Project	IEEE 802.16 Broadband Wireless Access Working Group < http://ieee802.org/16 >	
Title	WirelessMAN-SCa Support for AAS	
Date Submitted	2004-03-13	
Source(s)	<p>Brian Eidson Conexant Systems, Inc. 9860 Scranton Rd, Suite 1000 San Diego, CA 92121 USA</p> <p>Robert Nelson MacPhy Technologies 1104 Pittsburgh Landing Richardson, TX 75080</p>	<p>Voice: +1 858 713-4720 Fax: +1 858 713-3555 mailto: brian.eidson@conexant.com</p> <p>Voice: 972-239-9224 Fax: 972-671-1455 mailto: bob_nelson@ieee.org</p>
Re:	Sponsor ballot on document <i>IEEE P802.16REVd/D3-2004</i>	
Abstract	Provides text describing support for AAS under WirelessMAN-SCa	
Purpose	For consideration of adoption during Sponsor Ballot Resolution for REVd/D3.	
Notice	This document has been prepared to assist IEEE 802.16. It is offered as a basis for discussion and is not binding on the contributing individual(s) or organization(s). The material in this document is subject to change in form and content after further study. The contributor(s) reserve(s) the right to add, amend or withdraw material contained herein.

WirelessMAN-SCa Support of AAS

Brian Eidson, Conexant
Bob Nelson, MacPhy Technologies

Figure 1—MAC frame contents with AAS elements

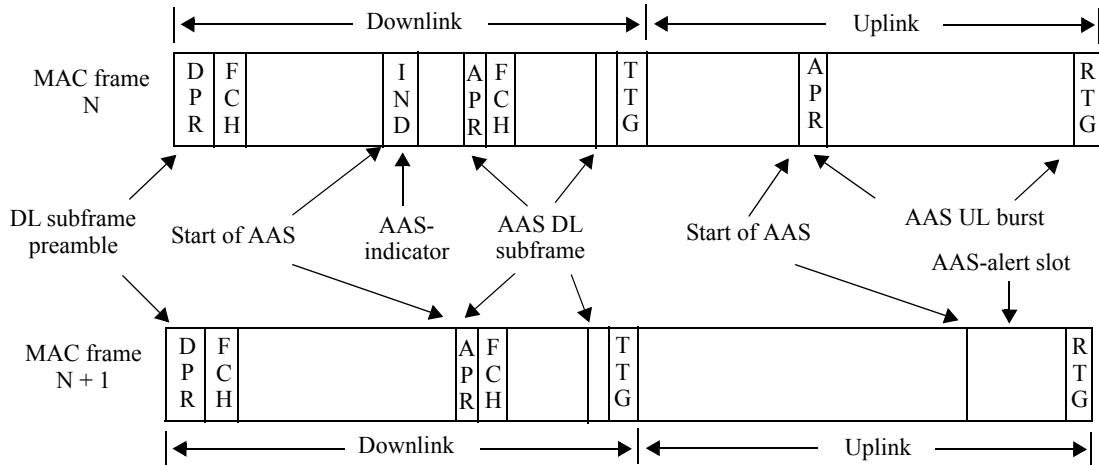
Elements associated with AAS transmission include an AAS-indicator, an AAS-alert slot, AAS-formatted downlink subframes, and AAS-formatted uplink bursts. An example of the content of MAC frames when AAS elements are included is presented in Figure 1.
